UNITED STATES PATENT AND TRADEMARK OFFICE

APPLICATION NO.	FILING DATE	FIRST NAMED INVENTOR	ATTORNEY DOCKET NO.	CONFIRMATION NO.
10/613,011	07/07/2003	Masahiko Hosokawa	392.1803	4508
21171	7590	06/16/2004	EXAMINER	
STAAS & HALSEY LLP SUITE 700 1201 NEW YORK AVENUE, N.W. WASHINGTON, DC 20005			SHECHTMAN, SEAN P	
			ART UNIT	PAPER NUMBER
			2125

Office Action Summary	Application No. 10/613,011	Applicant(s) HOSOKAWA ET AL.	
	Examiner Sean P. Shechtman	Art Unit 2125

DETAILED ACTION

FIG. 3

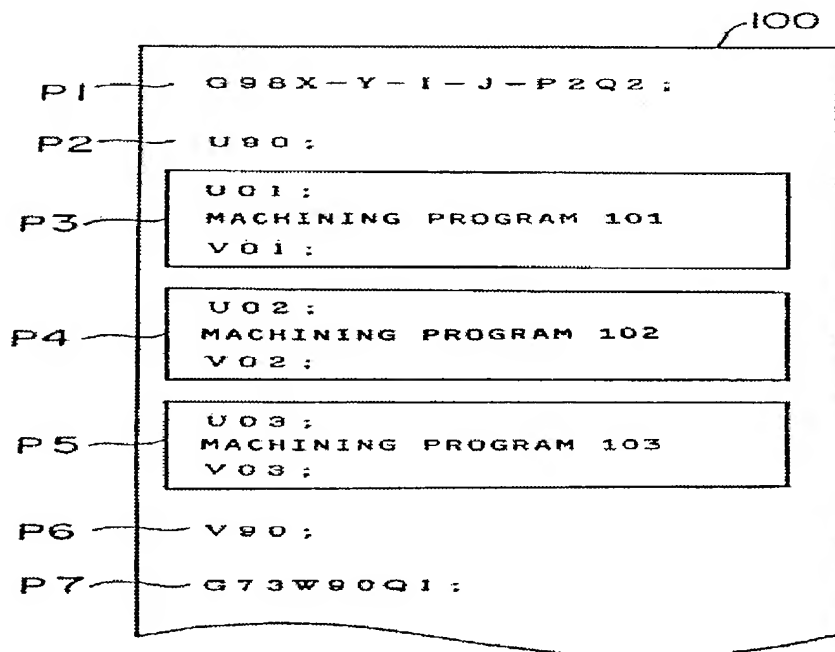
Referring to claim 1, Miyajima teaches a numerical controller for controlling a machine according to a machining program (Abstract), comprising:

a storage device or medium for storing input/output units (Fig. 3, element 100; Col. 4, lines 45-50) each including program block data (Fig. 3, elements P3-P5, programs 101, 102...) and additional information associated with the program block data (Fig. 3, elements P3-P5, start commands beginning with U and end commands beginning with V);

said program block data is obtained by dividing the machining program (See Fig. 3 below);

said additional information including front input/output unit data designating an input/output unit immediately preceding each input/output unit (Fig. 3, elements P3-P5, start commands beginning with U) and rear input/output unit data designating an input/output unit following each input/output unit (Fig. 3, elements P3-P5, start commands beginning with U and end commands beginning with V) in a sequence of the machining program (Col. 3, line 66 – Col. 4, line 9);
